**Town of Kittery
 Planning Board Meeting
 May 12, 2016**

93 Picott Road – Right of Way Plan Review

Action: Approve or deny plan. Owner Herbert and Carolynn Marsh and applicant Graystone Builders, Inc. propose a Right-Of-Way to access two new lots located at 93 Picott Road (Tax Map 49 Lot 7) in the Residential-Rural (R-RL) Zone. Agent is Bill Anderson, Anderson Livingston Engineers.

Staff Review

PLAN OF PROPOSED PRIVATE RIGHT OF WAY FOR GRAYSTONE BUILDERS, INC. 93 PICOTT ROAD KITTERY, MAINE

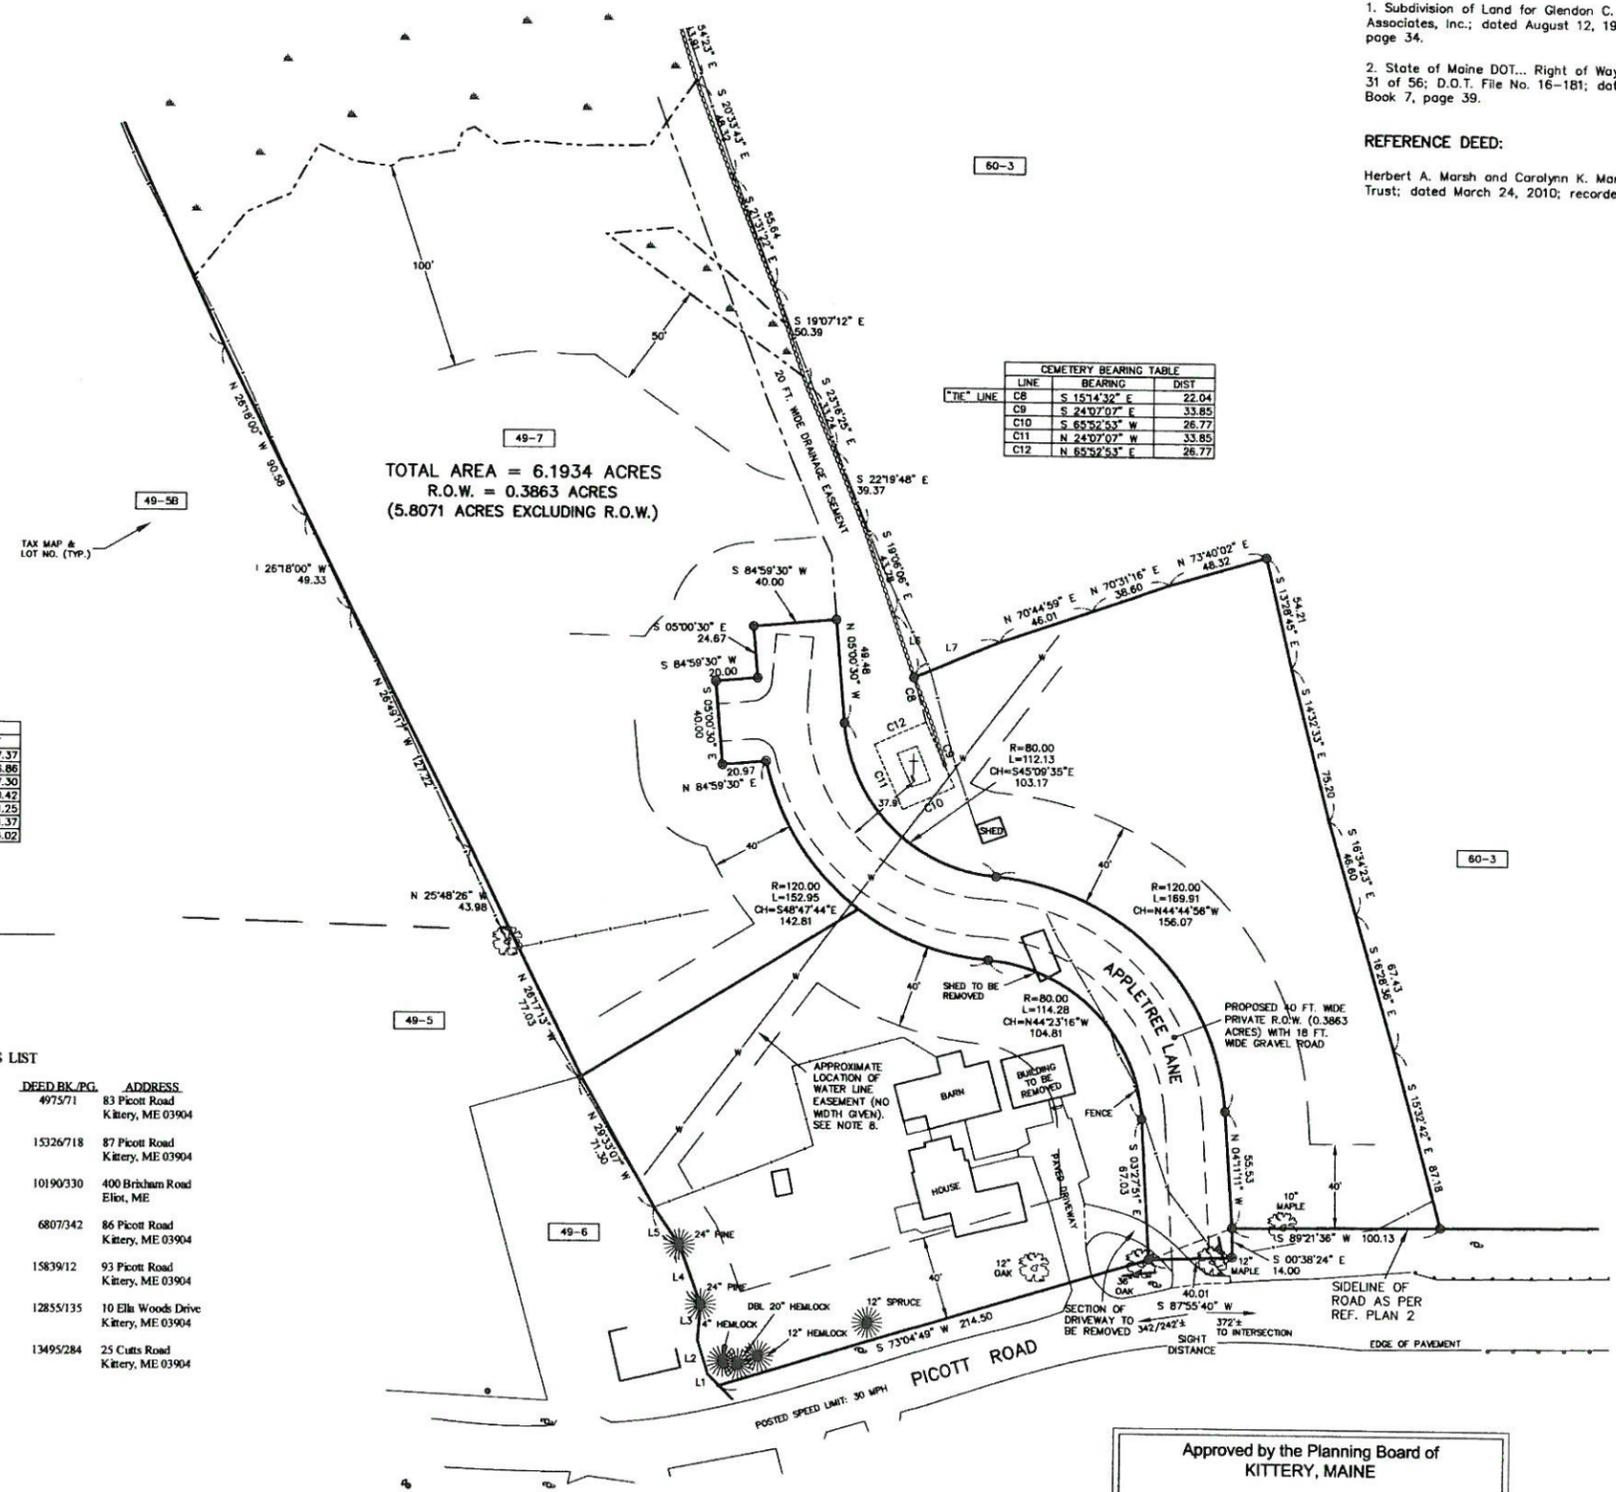
3. **16.8.4.10 – ROW streets are to be rough-graded full width.**
4. The proposed ROW would alter the classification of the existing dwelling to a corner lot condition per the 16.2.2 definition of *Corner Lot*. With the ROW as shown, the dwelling would be subject to the following:

- a. The side yard, determined as the yard located between the principal building and the side street, may not be less than the front yard requirements. The minimum front yard in the R-RL zone is 40 feet. The proposed ROW creates a side yard of 23-feet and does not conform to zone standards. **UPDATE:** (4/14/2016) The applicant has agreed to remove an existing building that would have prevented conformance with the Corner Lot front/side yard setback requirement. All proposed front and side yard setbacks are in conformance with zone standards. The applicant has submitted a revised plan to show all front and side yard setbacks to the proposed ROW.

5. The plan depicts a cemetery on the lot, which requires a 25-foot setback for the ROW. The proposed ROW is 22-feet from the edge of the cemetery as depicted and may not conform to State statute. The applicant needs to confirm the bounds of the cemetery per Title 16.2.2 definition and clarify on the plan that there must not be any disturbance within 25-feet of the existing cemetery per MRSA 13 § 1371-A. **UPDATE (5/12/2016):** The revised plan depicts a boundary around the existing cemetery that appears to meet the 16.2.2 definition of *Cemetery Burying Ground* and the requirement for determining the perimeter when no boundary is apparent. It also appears from the plan that the edge of pavement for the proposed street is 25 feet from the perimeter referenced above, however, it is not clear if this satisfies the state statute 13 § 1371-A "...construction or excavation may not be conducted within 25 feet of a known burial site or within 25 feet of the boundaries of an established cemetery, whichever is the greater..." As the roadway section depicts on sheet 2, there will likely be "construction" and probably some "excavation" within the 25-between the edge of payment and the cemetery's perimeter. The plan does denote (sheet 2 Road Construction Plan) that 37.9 feet between the headstone and the edge of pavement is required, however, this does not equate to 25 feet from the boundary of the cemetery. If the Board concurs that the required setback is measured from the perimeter of the cemetery and not the headstone in the cemetery, the Board may want to require the applicant to provide proposed grading in this area to demonstrate that the proposed construction will conform to the required setback. See condition of approval 6b.

9. The graphic scale on the plan depicts 1 inch = 50 feet. However the actual scale the plan is plotted at is 1 inch = 40 feet. **UPDATE (4/14/2016):** Revised plans continue to depict 1 inch = 50 feet. Final plans will need to show the actual scale of 1 inch = 40 feet. **UPDATE (5/12/2016):** The plan has been revised.

- 1) Update the plan with the following revisions. **UPDATE (5/12/2016):** All items have been addressed with the exception of added d) and e)
 - a) Depict proposed front yard setbacks for ROW

- b) Depict front, side and rear yard setbacks for the existing dwelling and parcel.
 - c) Update graphic scale
 - d) Revise ROW plan to include a note in vicinity of the depicted cemetery that "there will be no construction or excavation within 25 feet of the perimeter of the cemetery" and also include a dimension line that depicts the 25-foot setback. The Road Construction Plan (sheet 2) should be revised in the same manner.

- e) Remove the property line north west of the existing building
 - 2) Revise the proposed ROW so it conforms the dimensional standards of the R-RL zone with consideration of the corner lot as defined in Title 16.2.2. **UPDATE (5/12/2016)** Plan has been revised to address this.

- **Corner Lot Definition.** As we previously discussed I feel the ordinance contradicts itself by allowing a reduction of the front setback on side roads but then takes it away, this should be corrected. It is not critical to this application so we have modified the plan to show a front setback to all roads.

- **Sight Distance.** This has been added to the plan.
- **Water Supply.** The Kittery Water District has determined that since they have a water main already crossing the property in the area of all of the potential houses no main extension would be required, only individual service connections to the existing main.
